SUBJECT: Provides addl info re NPDES Permit Application PA 0047325, in response to 841022 telcon questions. Info includes revised water use diagram as well as info updating permit application.

SUSQUEHANNA STEAM ELECTRIC STATION
NPDES PERMIT APPLICATION SUPPLEMENTAL INFORMATION
PERMIT NO. PA 0047325
CCN 741326
FILE 012-3
PLE-6239

SUSQUEHANNA SES
WATER USE
DIAGRAM. (REV. 11/84)

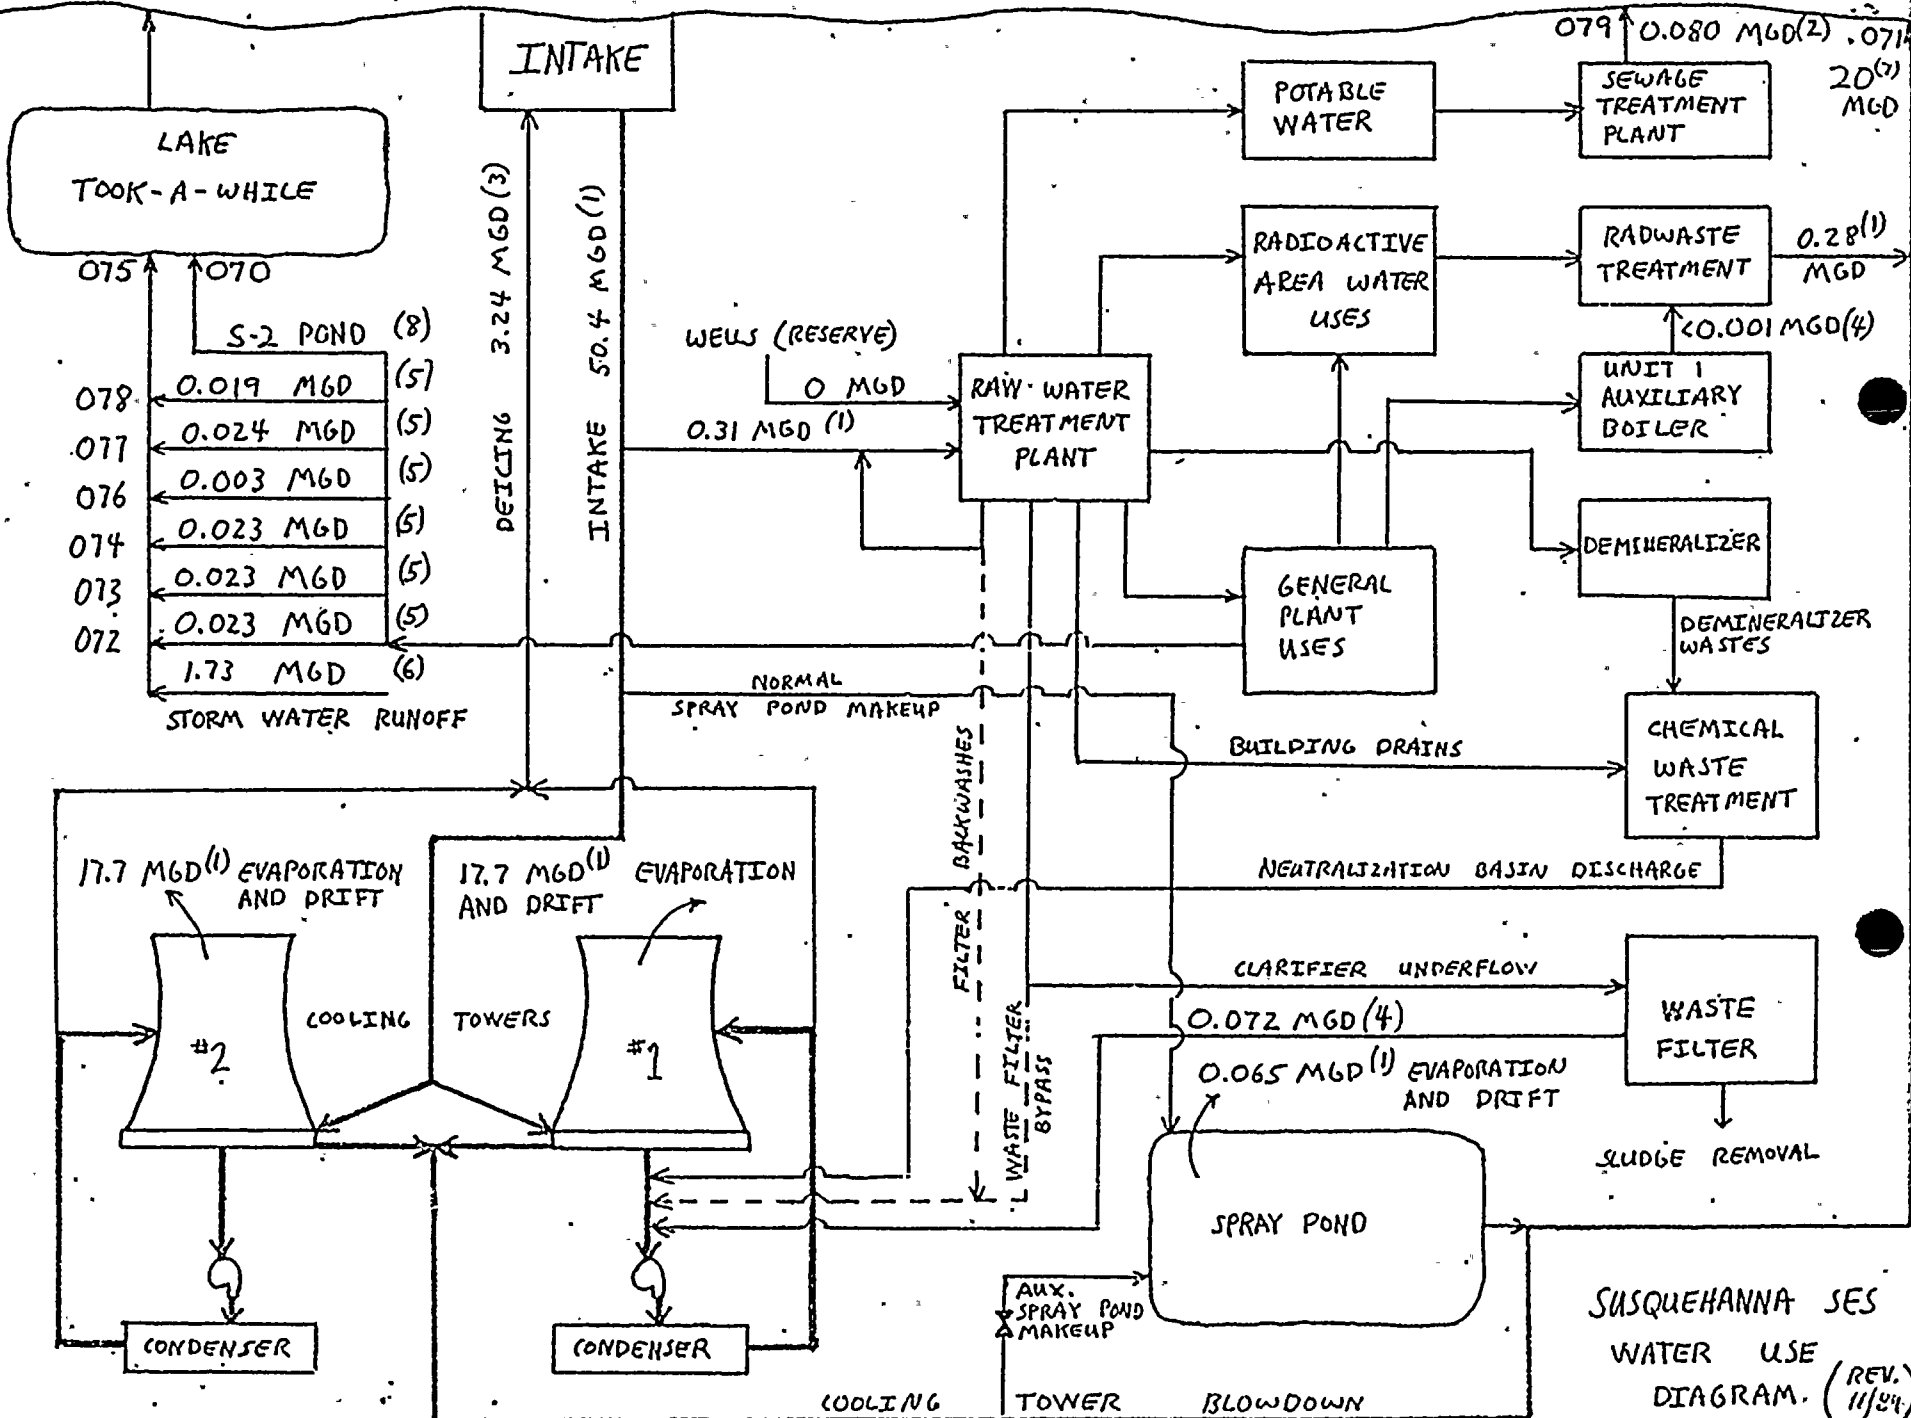
1. Attached is a revised Water Use Diagram which reflects changes that have occurred in plant operation and wastewater discharges since the March, 1984 permit application. Temporary bypasses are shown on the diagram with dotted lines.

- A. As stated in the March, 1984 permit application, the clarifier underflow from the raw water treatment plant is being directed to the circulating water system (circwater), due to waste filter operational problems. Once this system becomes operational, this underflow will be directed to the waste filter where the sludge will be removed for disposal and the water portion returned to circwater.

- B. Backwashes from two filters, a gravity sand filter and a carbon filter used in the raw water treatment plant, combine with the temporary bypass of the waste filter prior to discharge to circwater. These backwashes were originally intended to be returned to the raw water clarifier. However, due to operational changes these backwashes are now being directed to circwater. Since these changes are not finalized, these filter backwashes may be routed back to the raw water clarifier in the future.

- C. Wastewater from chemical waste treatment (neutralization basins) will not be directed to the waste filter as previously indicated. These basins are used to neutralize acids and caustics used in regenerating the demineralizers. Since this effluent contains little suspended solids, this waste stream will be discharged directly to circwater rather than placing an unnecessary hydraulic load on the sludge filter.

5. The deicing line shown on the water use diagram supplies warm water from circwater to a series of nozzles located just inside the intake structure. During cold weather operations, water is sprayed on the traveling bar screens and the intake channels to remove or prevent ice formations. This system represents no discharge to the river, since any water used for deicing purposes is drawn further into the intake structure and then pumped back to the cooling towers with the intake water.

6. The temporary butter tank listed under outfall 078 on Form 2C and under the Supplement to Item II.B. - Further Description of Outfalls - pg. 7, has been removed. Thus, there will be no discharges from this tank.
7. Monitoring at outfall 070, the S-2 sedimentation pond, can be accomplished by sampling at the sedimentation basin's overflow pipe.
8. Makeup to the spray pond normally occurs directly from the intake line as shown on the water use diagram. However, makeup to the spray pond can also occur from the cooling tower blowdown line.
